**MONITORING YEAR 1
ANNUAL REPORT**
Final

CROSS CREEK RANCH SITE

Subject: Cross Creek Ranch Site – Monitoring Year 1 Draft Report
Montgomery County, NC
Yadkin River Basin – CU# 03040104
DMS Project ID No. 100138
Contract # 7879-01

Review Comments:

Groundwater Gauge Plots

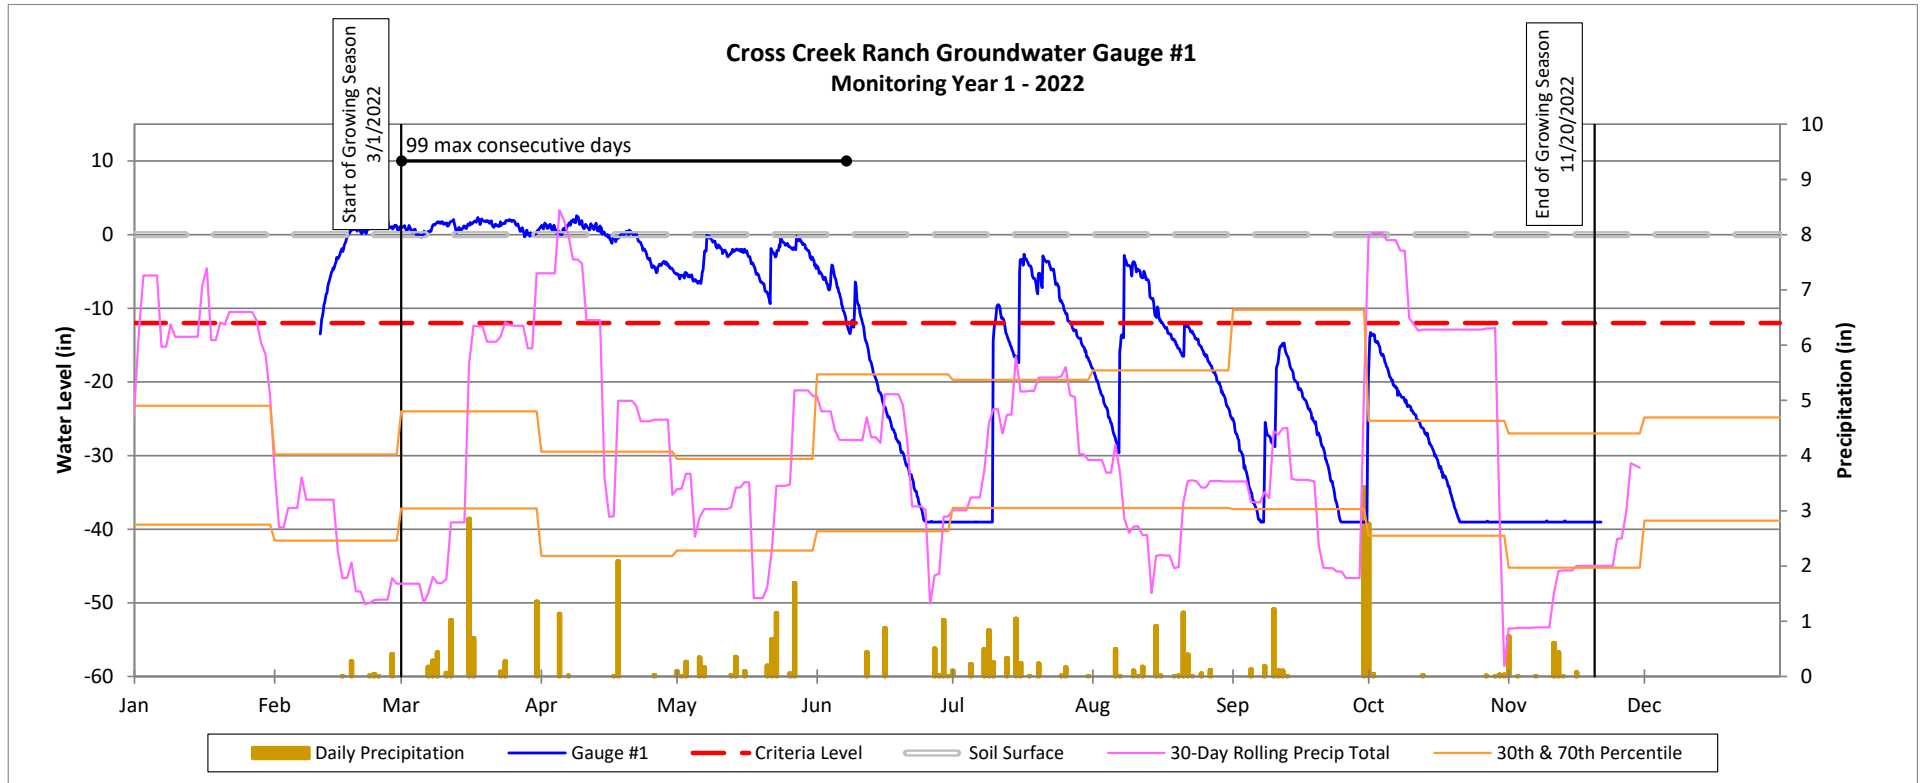
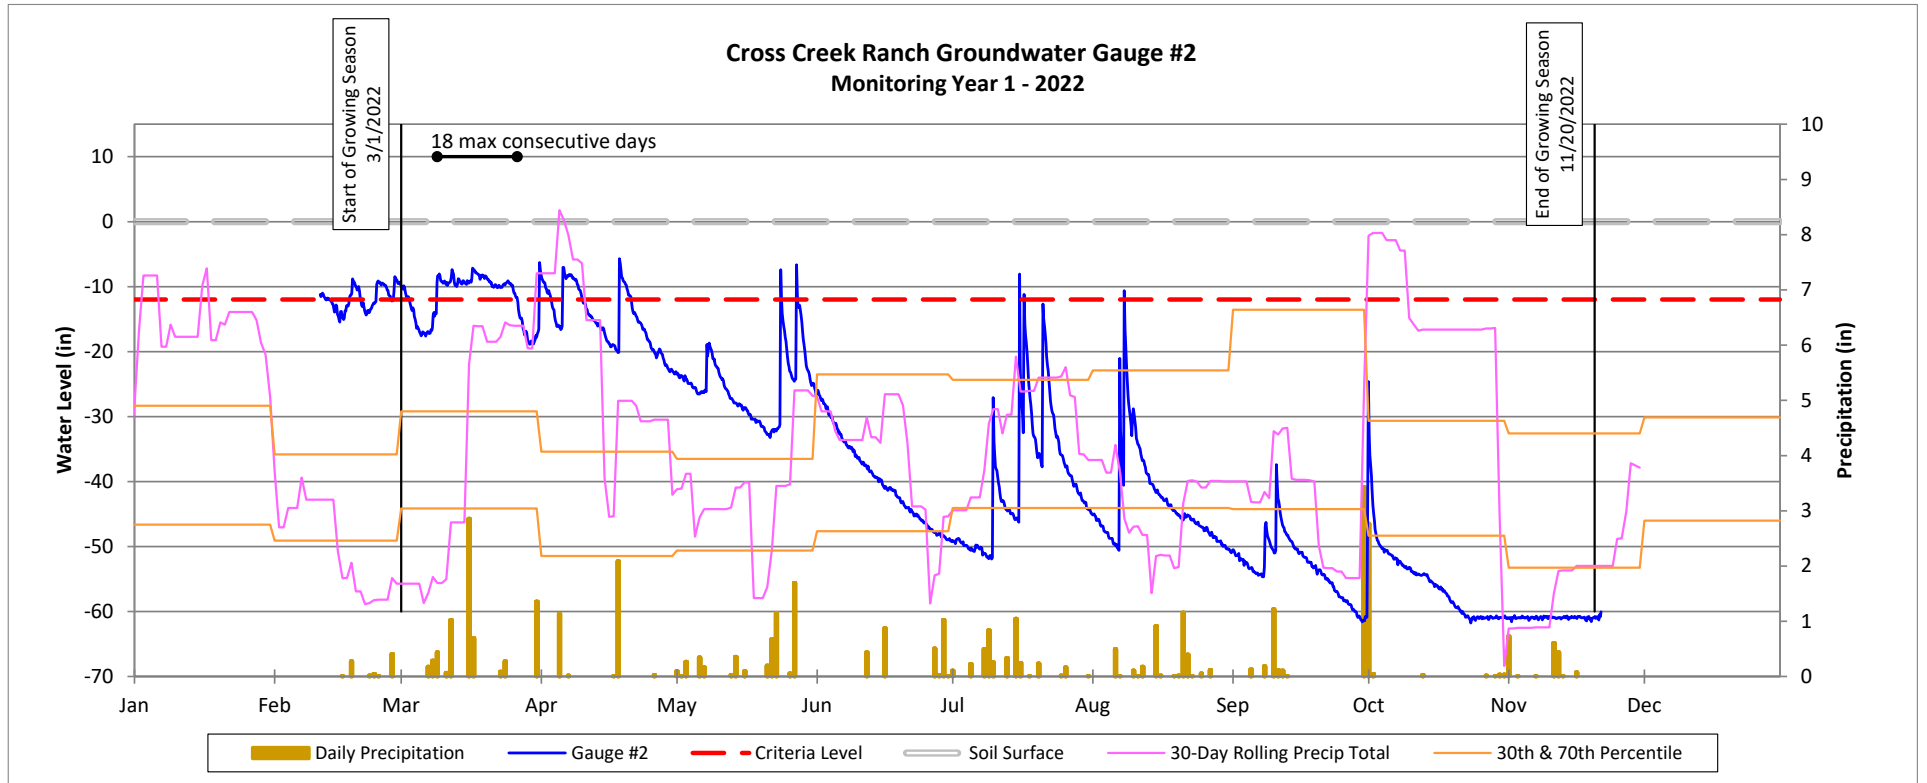
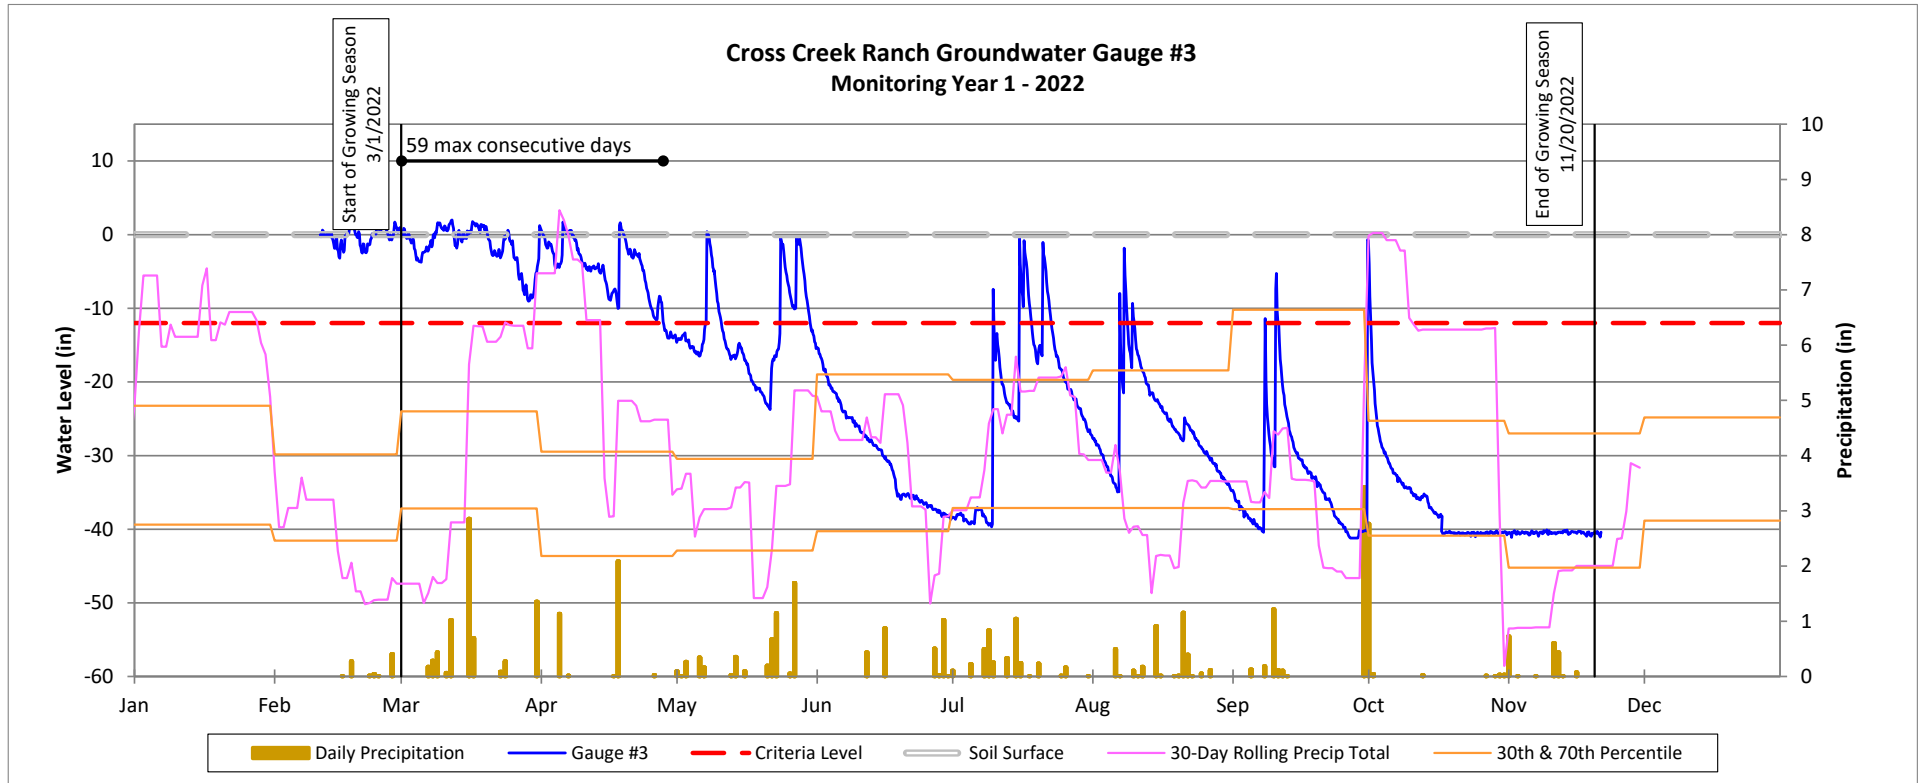
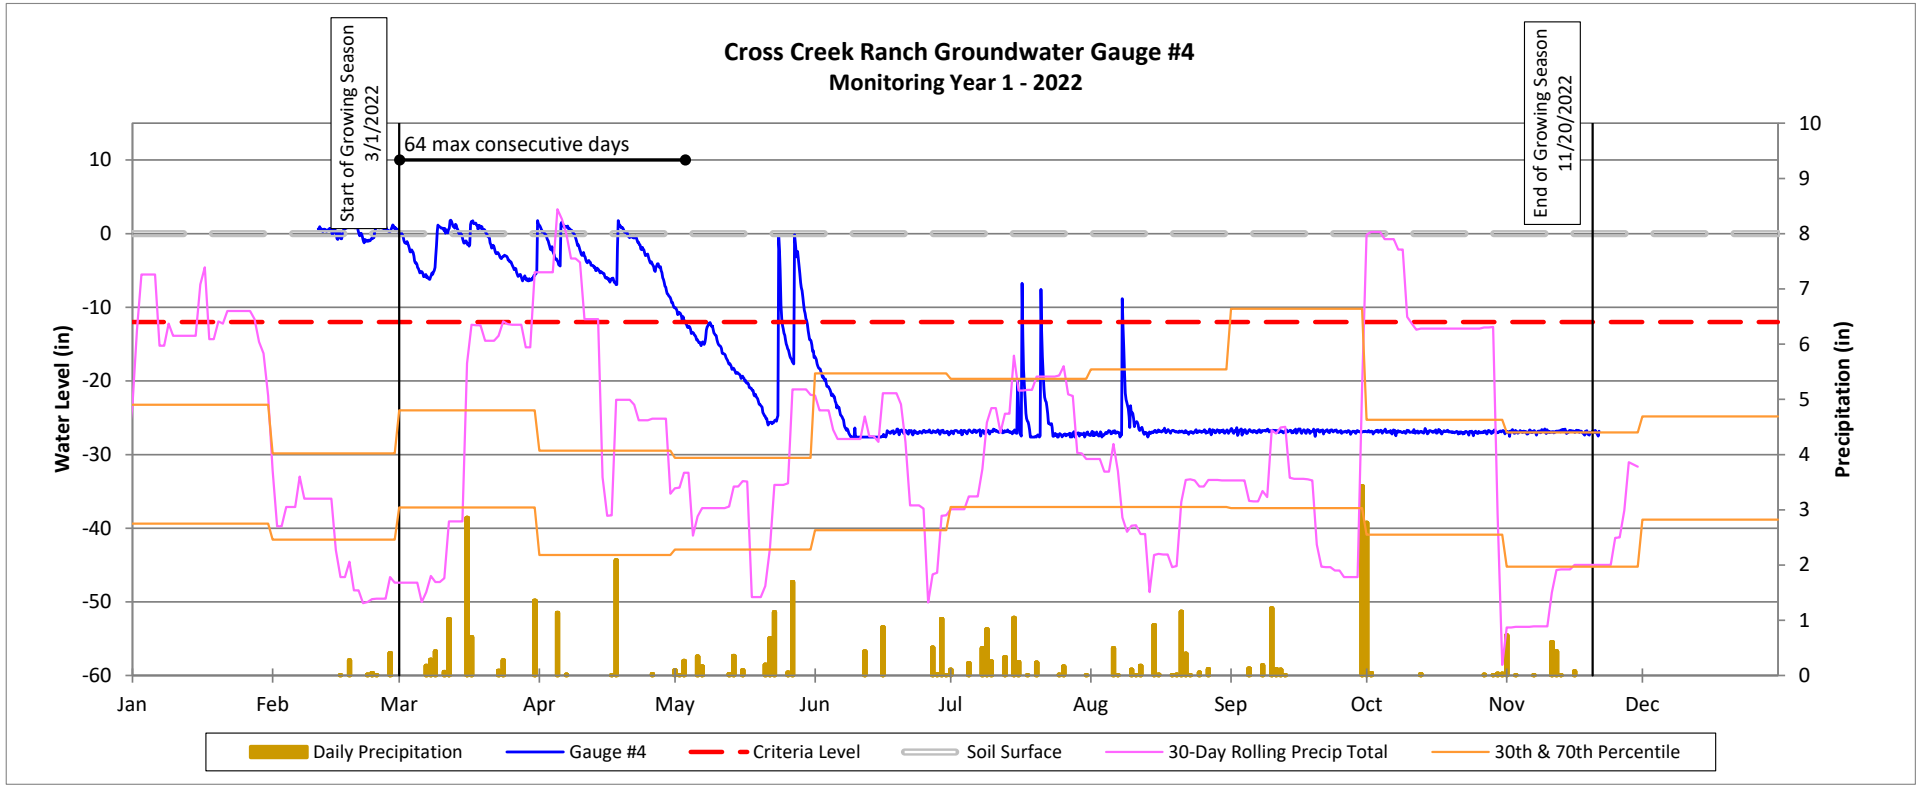
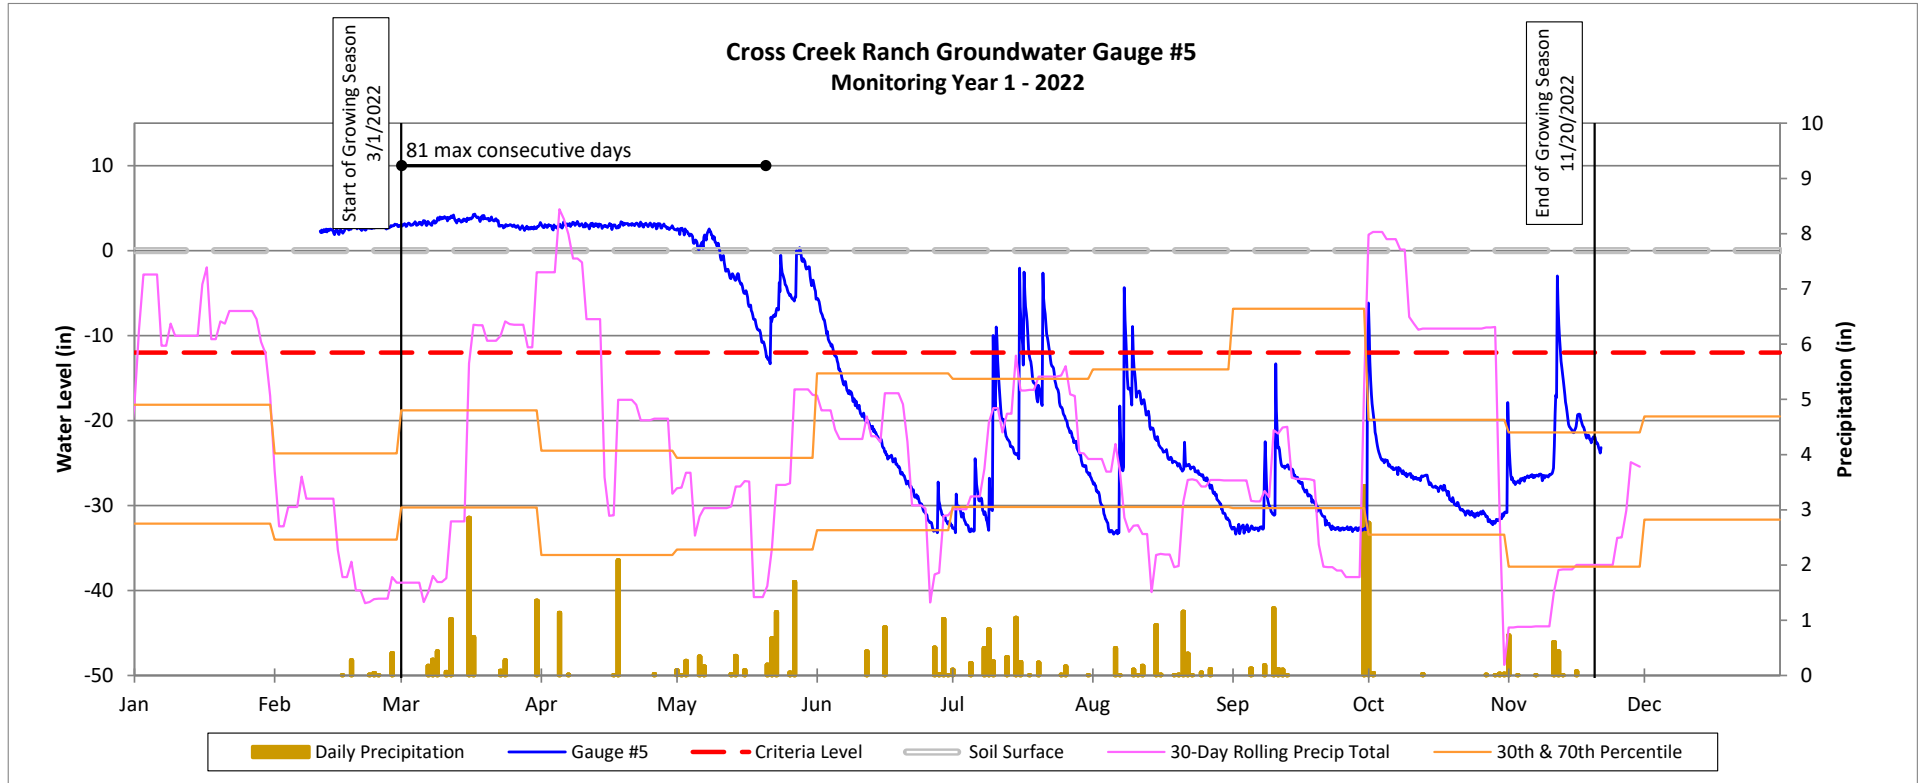
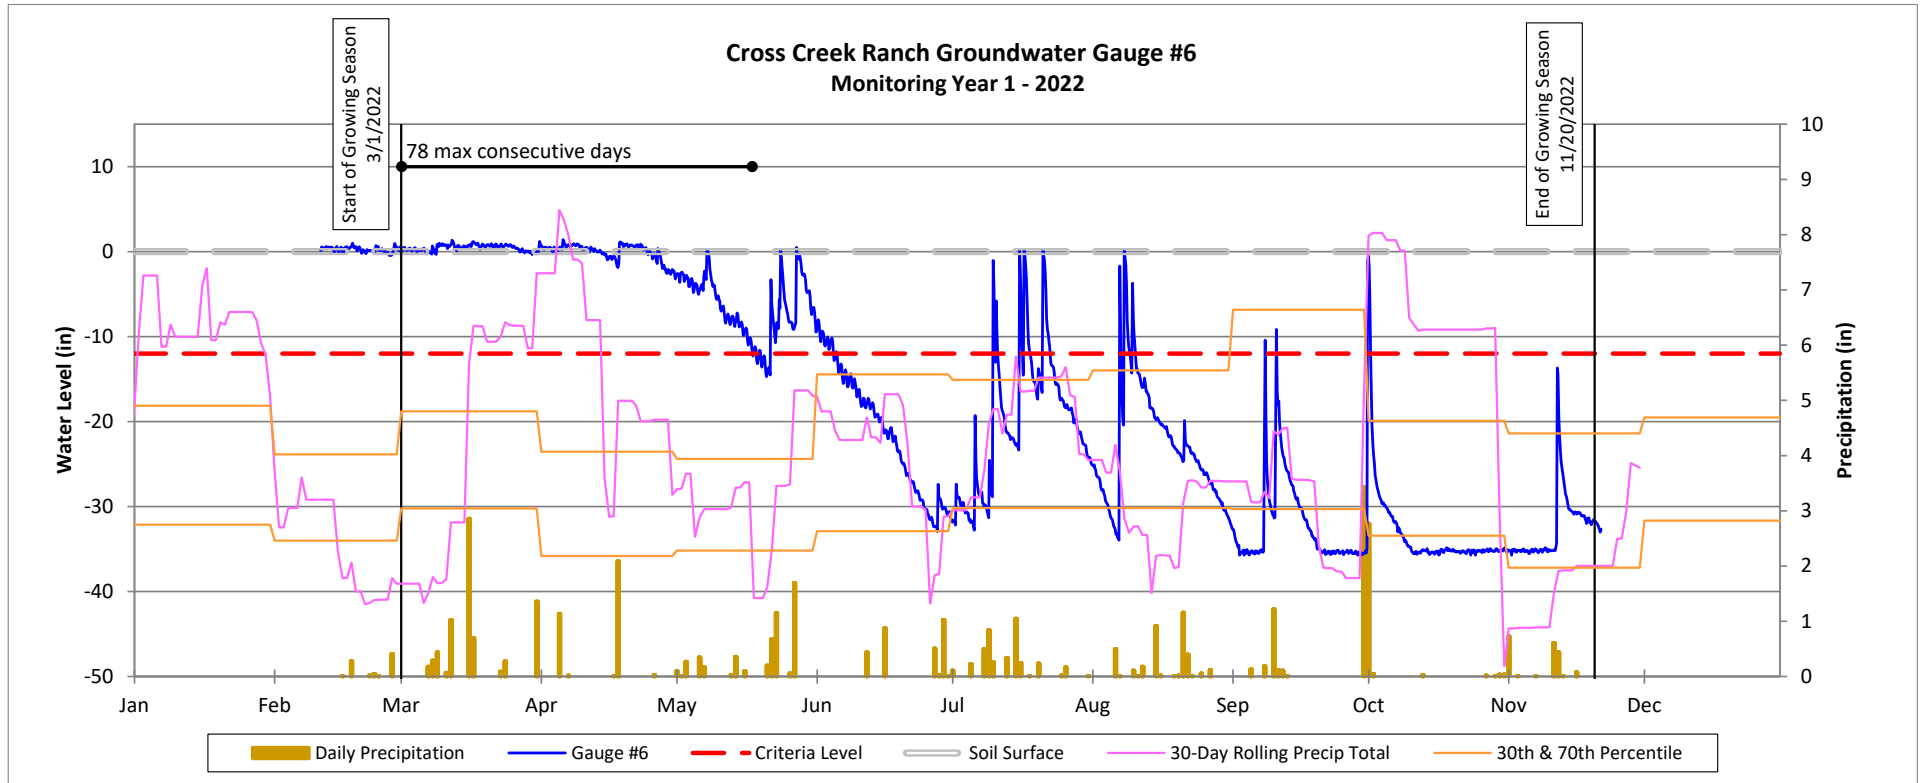
- [2.6 Wetland Assessment: Gages 2, 7, and 9 did not meet their respective hydroperiods. DMS conducted a field inspection on December 9, 2022, which raised the question, are these three wells representative and useful for interpreting wetland classification? Add discussion that identifies the relative gage locations and elevations within the local wetland topography. Are the gages installed on isolated ridges with localized wetland boundaries? Have the gages been field calibrated in their respective installations to accurately correlate their pressure readings with a measured depth to water from ground surface?](#)

Response: In an effort to best represent the conditions of each wetland re-establishment and rehabilitation zone, gauges 2, 7, and 9 are placed within the middle of their respective wetland boundaries. All gauges are calibrated correctly to accurately correlate their pressure readings with a measured depth to water from ground surface. After construction of the stream channel, it is anticipated that the groundwater table will take some time to recharge. Additional seasons of water table observation are required to better understand hydrology at the Site and thoroughly evaluate the success of wetland re-establishment areas. While Wildlands believes groundwater

wells 2, 7, and 9 to be placed in a way that best interprets wetland classifications, Wildlands will further investigate locations of gauges 2, 7, and 9 in MY2. Wildlands will continue to monitor the success of wetlands wells failing to make their hydroperiods and will add wells accordingly if needed in the future.
